SUSQUEHANNA STEAM ELECTRIC STATION
HUMAN FACTORS REVIEW MODIFICATIONS
ER 100450 FILE 841-2
PLA-768

DOCKET NOS. 50-387
AND 50-388

ATTACHMENT TO PLA-768

PP&L changes its response to item 5j of the Human Factors Engineering review to the following:

Figure 4.

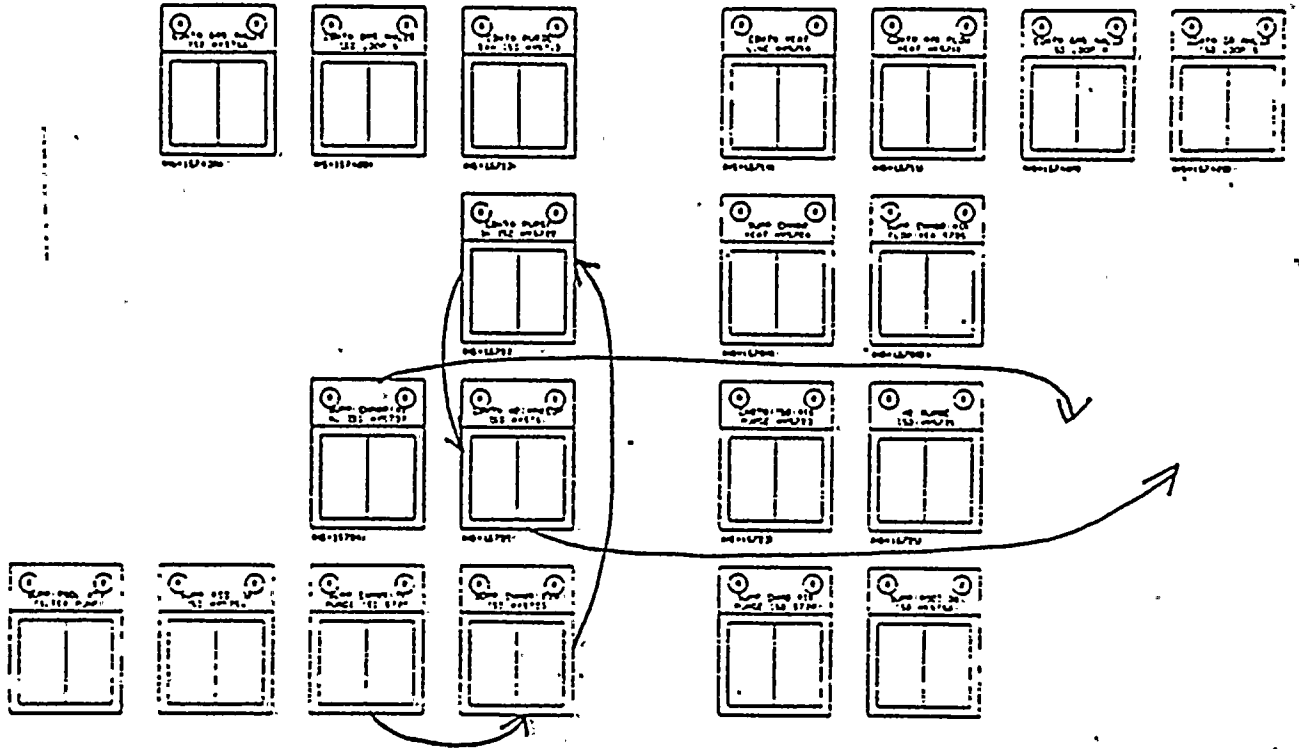
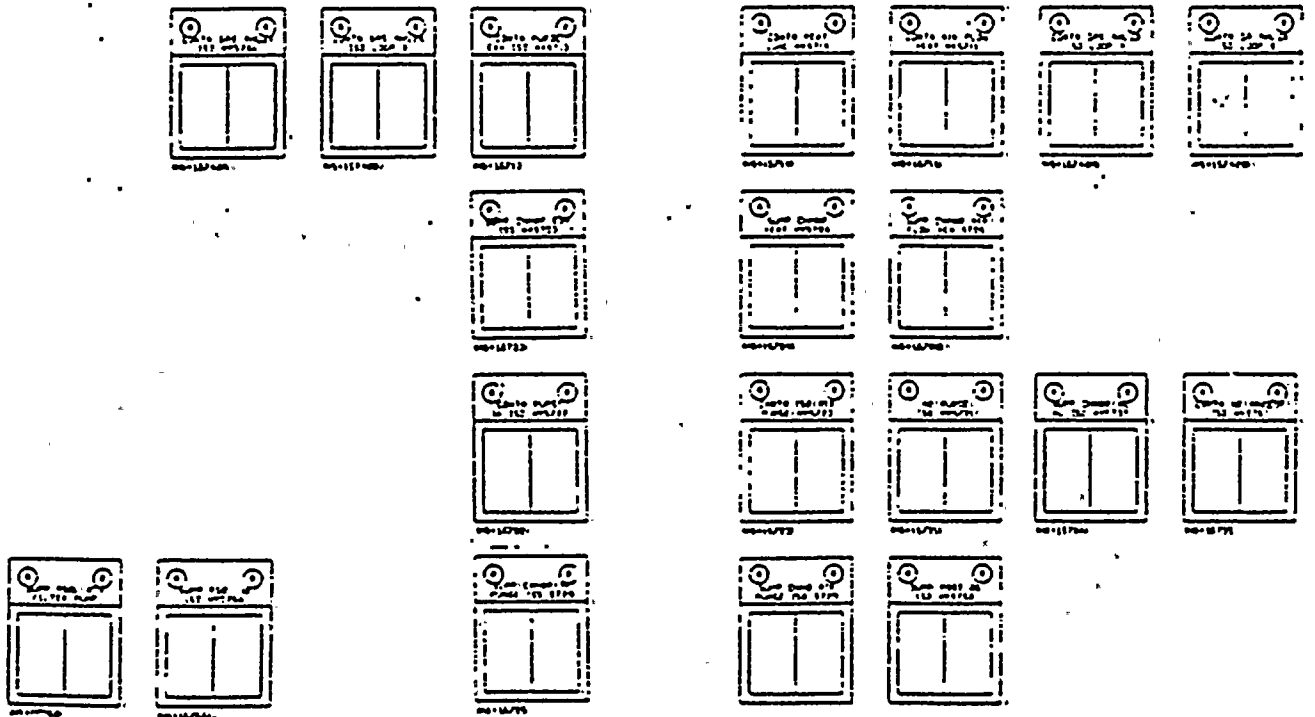
The control switches for containment atmosphere control (Subpanel 20c) will be arranged to provide a functional grouping that is consistent with the operation of the equipment. Enhancements will be added to clarify the functional groups.

In our original recommendation we stated that switches would be moved to address separation concerns. However, our final solution to the separation concerns resulted in a configuration different from Figure 4 in our report. This forced us to modify the layout of the switches to address the functional grouping criteria. The attached drawings show the original figure from our report and a new figure showing the change.
